Case File Number: PLN15048, T1500023, ER15001

May 25, 2016

Location:	Mountain View Cemetery (Piedmont Avenue, near Pleasant Valley); 5000 Piedmont Avenue; APN: 048A700200302
Proposal:	Expand cemetery development in currently undeveloped portions of existing cemetery to accommodate future additional burial sites.
Applicant:	Mountain View Cemetery Association, Jeff Lindeman, (510) 658-2588.
Owner:	Mountain View Cemetery Association
Planning Permits Required:	Major Conditional Use Permit, Design Review, Tree Removal Permit, Creek Permit, compliance with CEQA.
General Plan:	Urban Park and Open Space
Zoning:	RD-1: Residential Low Density
Environmental Determination:	EIR
Historic Status:	“A1+” rating and API, OCHS
Service Delivery District:	2
City Council District:	1 -- Kalb
Action to be Taken:	Conduct preliminary design review
Finality of Decision:	NA
For further information:	Contact case planner Catherine Payne at 510-238-6168 or by e-mail at cpayne@oaklandnet.com

CITY OF OAKLAND PLANNING COMMISSION

AREA 3: SECTION AT CRYPT WALL

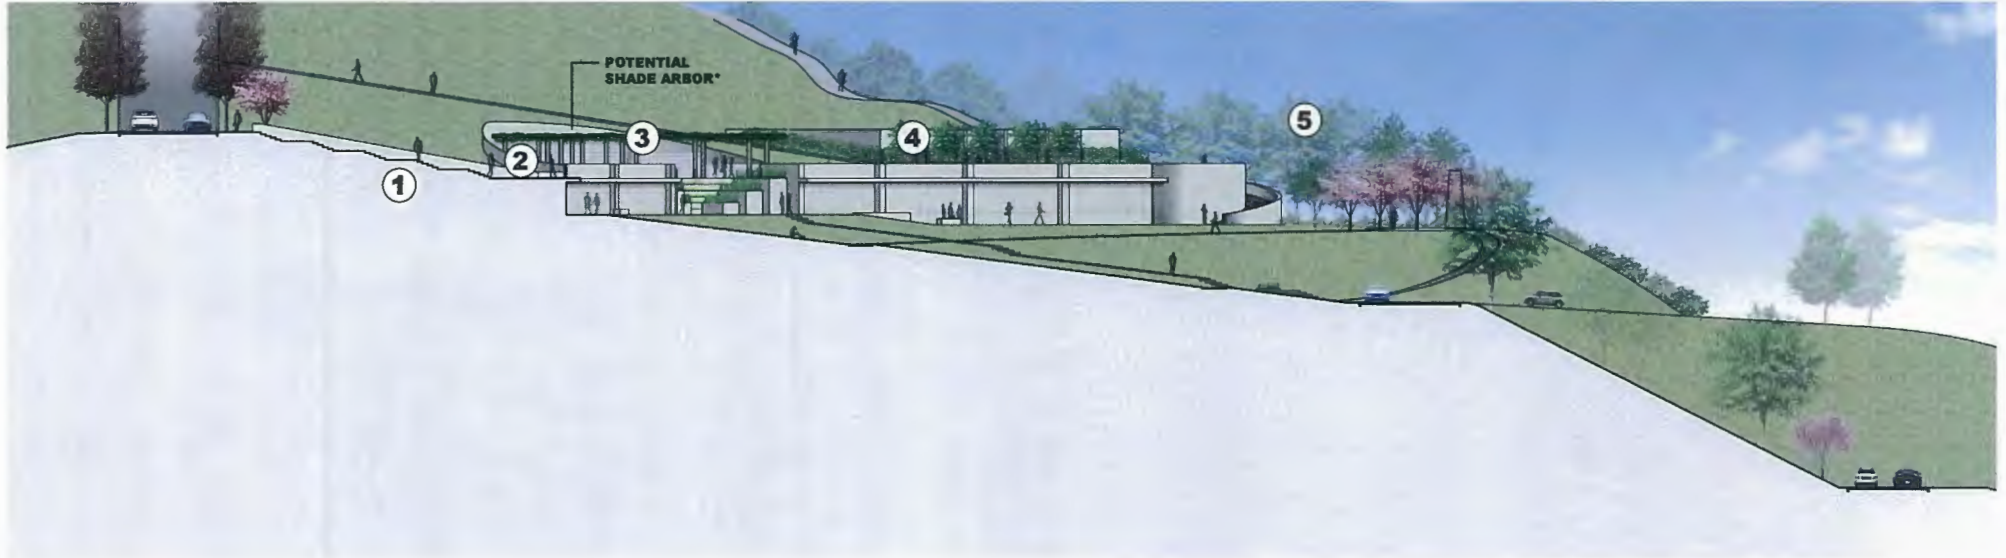
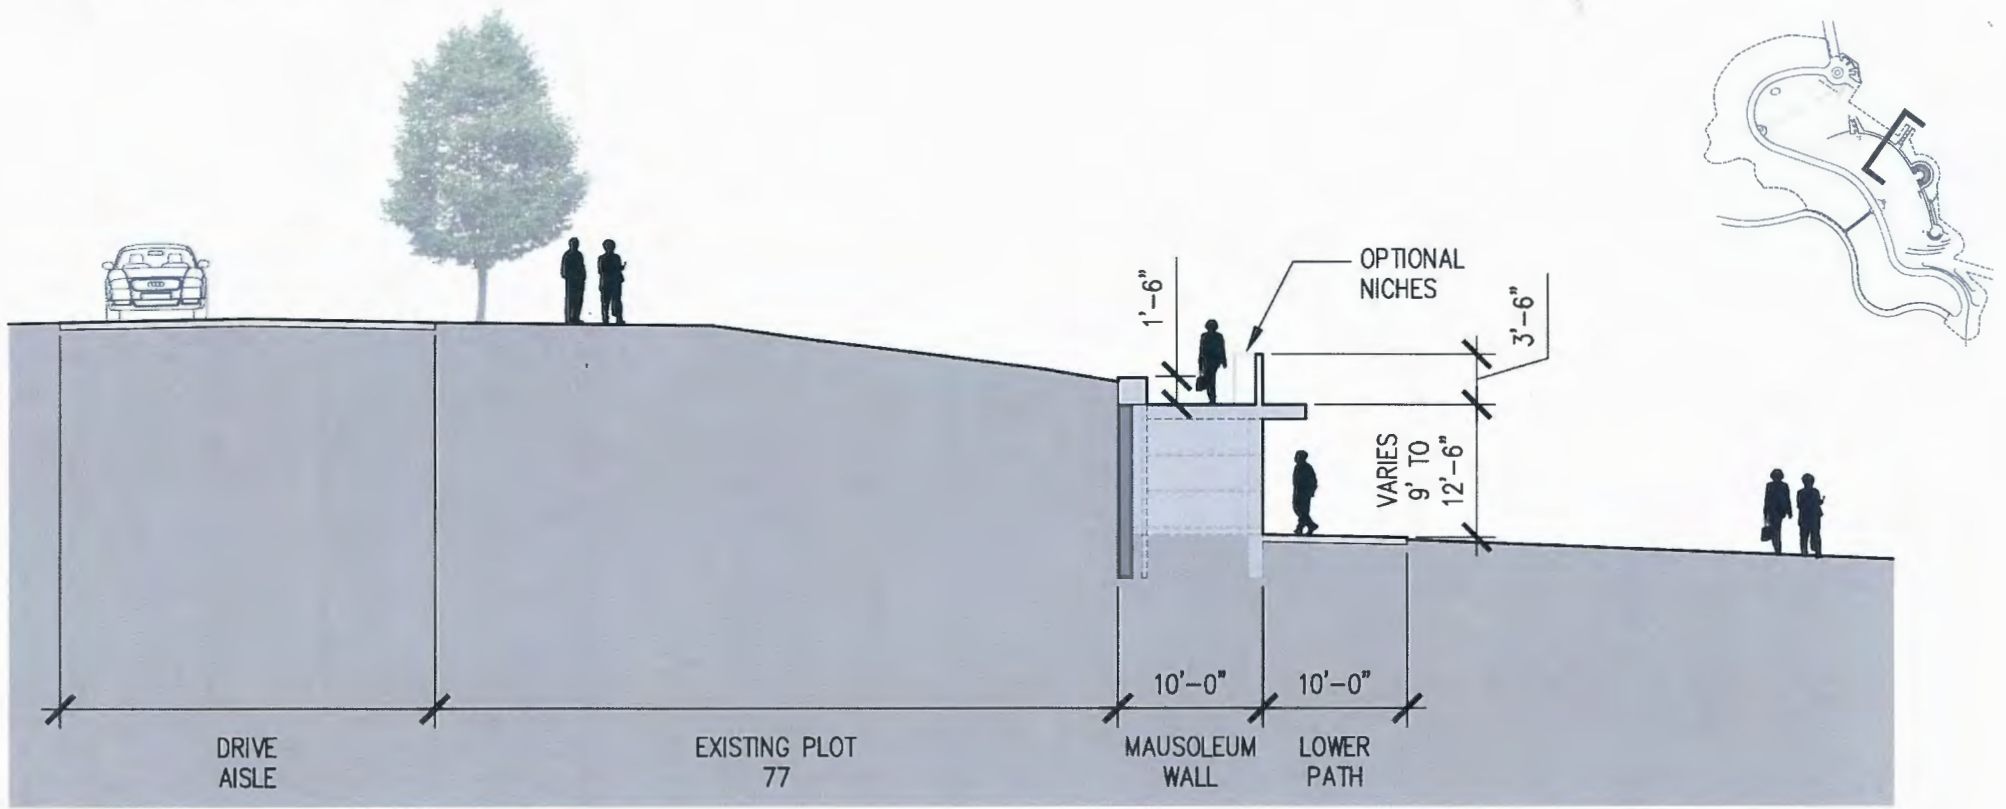
- The mausoleum wall would be over 600 feet long and up to twelve feet tall, with a safety railing (42 inches tall, minimum) above. This is a large feature in the landscape. Does the DRC have concerns, comments or suggestions regarding the length, height or design of this wall?
